Sheringham Shoal and Dudgeon Offshore Wind Farm Extension Projects

The Applicant's Comments on the Report on Implications to European Sites

Document Reference: 21.2

| Sheringham Shoal and Dudgeon Offshore Wind Farm Extension Projects Examination submission The Applicant's Comments on the Report on the Implications for European Sites (RIES) | |

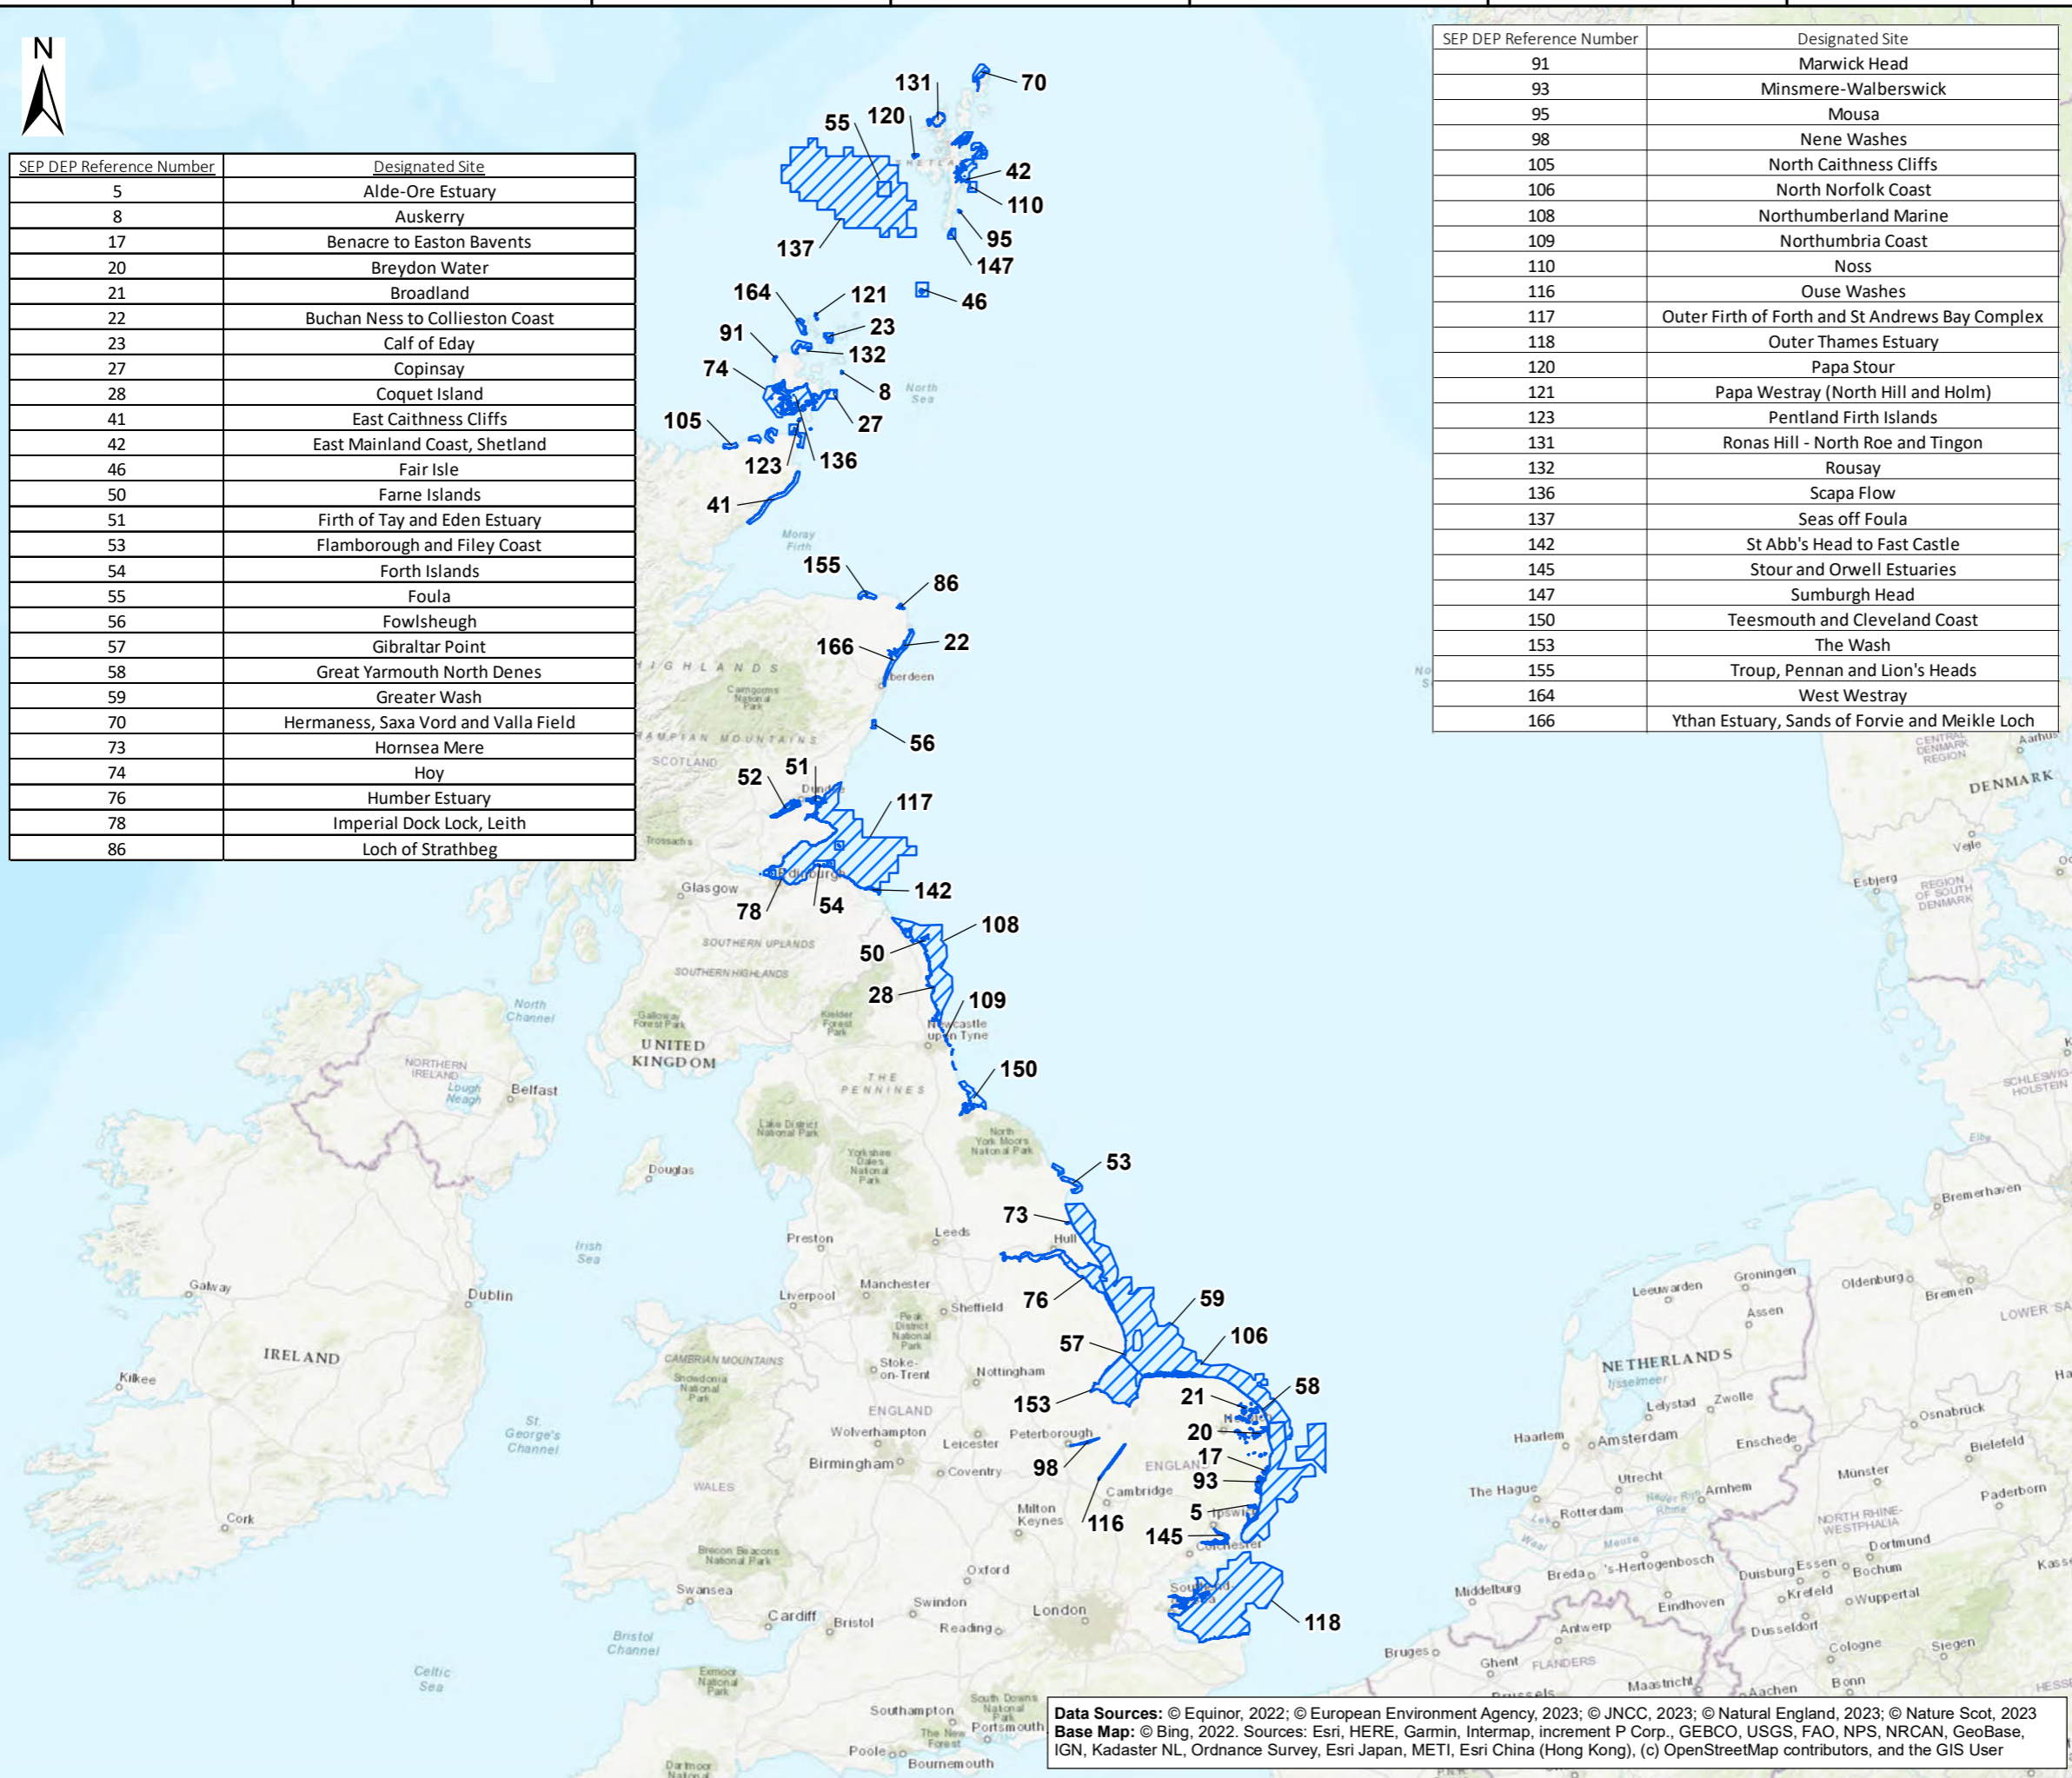
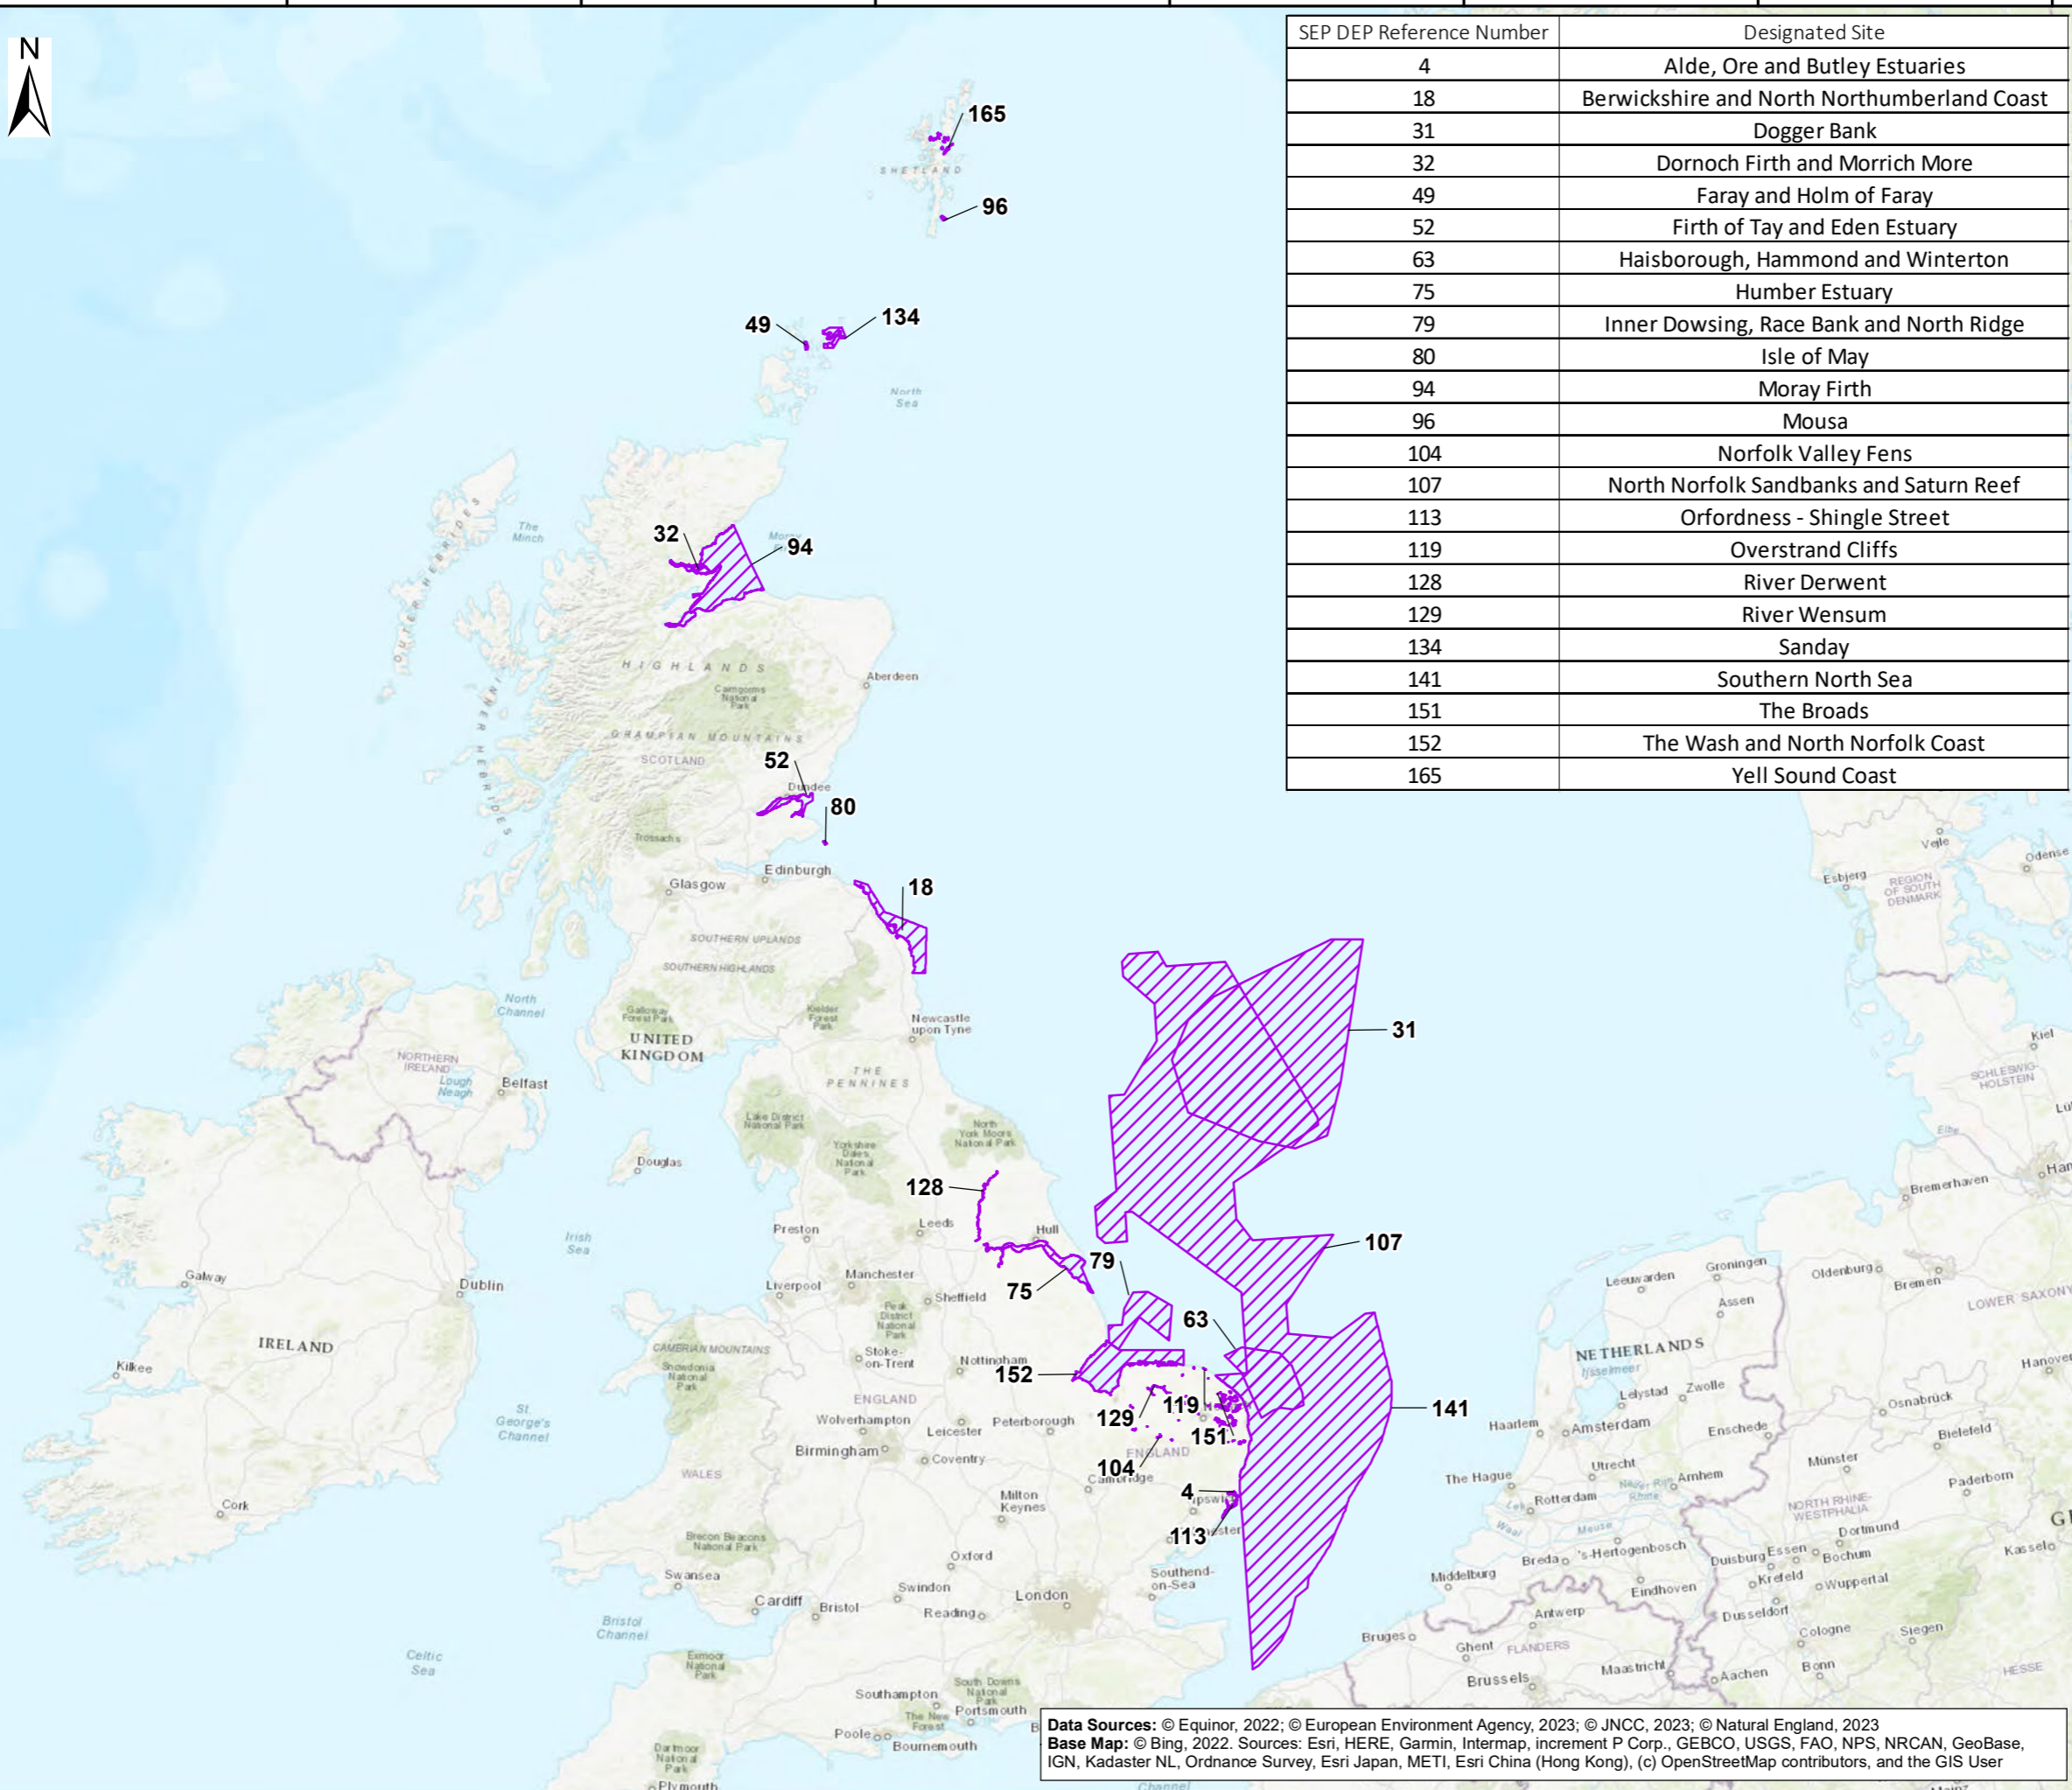
| RIES ID | RIES Question / Extract | Question Addressed to | Applicant Response |
|---------|---|-----------------------|--|
| RIES-Q1 | The Applicant is requested to provide further clearly labelled figures to show the extent of all European sites considered in the Applicant's HRA assessment in relation to the Proposed Developments, including a figure(s) to show non-UK European sites. | The Applicant | <p>These are provided in Annex I.</p> <p>Due to space limitations each figure is provided as follows:</p> <ul style="list-style-type: none"> • UK SPA AND RAMSAR • UK SAC • EUROPEAN SPA AND RAMSAR • EUROPEAN SAC (France) • EUROPEAN SAC (excluding France) <p>It should be noted that the 'SEP and DEP reference' number shown on each figure corresponds to those within Table 3-2 of the Habitats Regulations Assessment Screening Matrices (Revision B) [REP4-009].</p> |
